Access Compliance Report Public Rights-of-Way (Curb Ramps)

Main Street: GILBERT_ST Cross Street: KATELLA_AVE Location: NE

ADA ID: RPAT210916103336 Ramp Type: Type 1 - Perpendicular Diagonal Initial Pass/Fail: Pass Overall Compliance: No Severity Score: 0

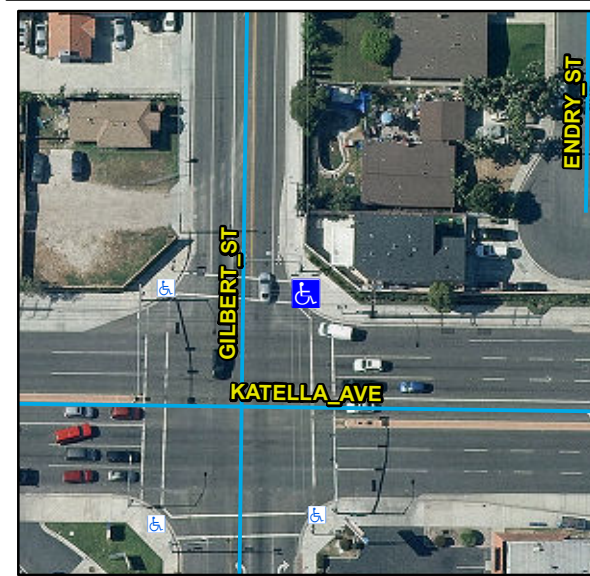
Possible Solutions:
Remove & Replace Landing.

OC Std/PROW:
R304.2.1, STD 1115
